MS9443
AMENDMENT 1
8 JULY 2003

BOLT, MACHINE - STEEL AMS 6304, DIFFUSED NICKEL-CADMIUM PLATED, HEXAGON HEAD, DRILLED, .375-24 UNJF-3A

This amendment forms a part of MS9443, dated 21 December 1962, and is approved for use by all Departments and Agencies of the Department of Defense.

Sheet 1

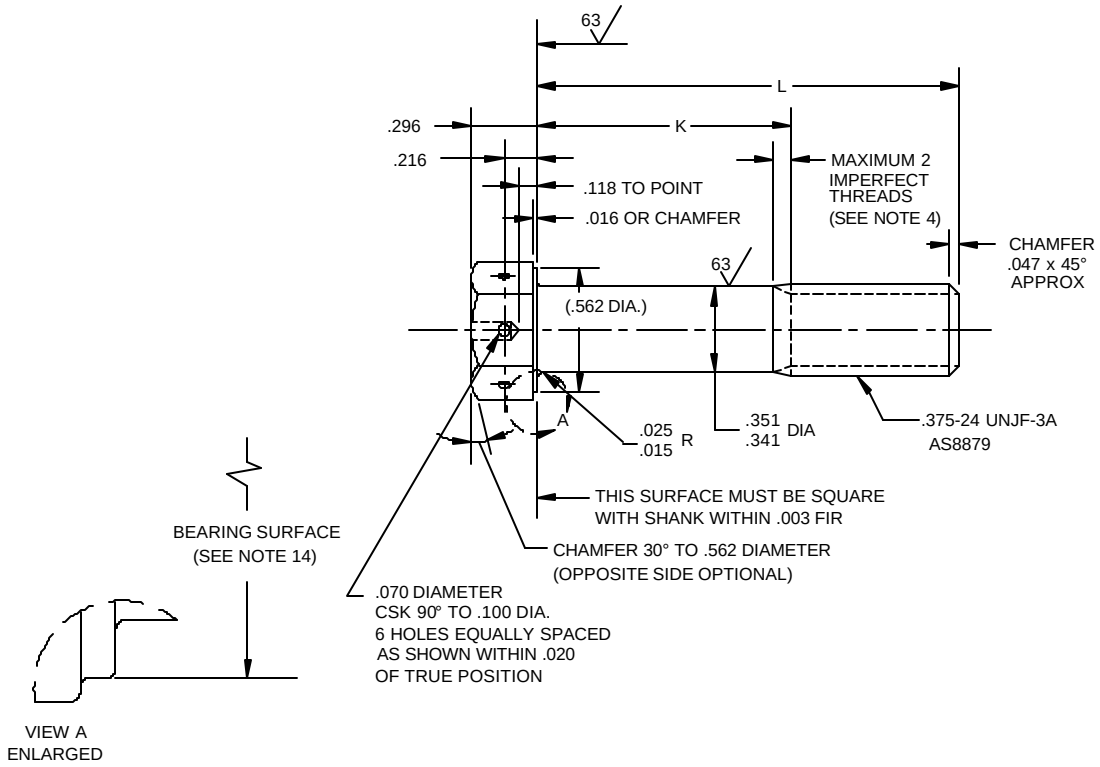
In drawing: Replace front view with this drawing and add View A.
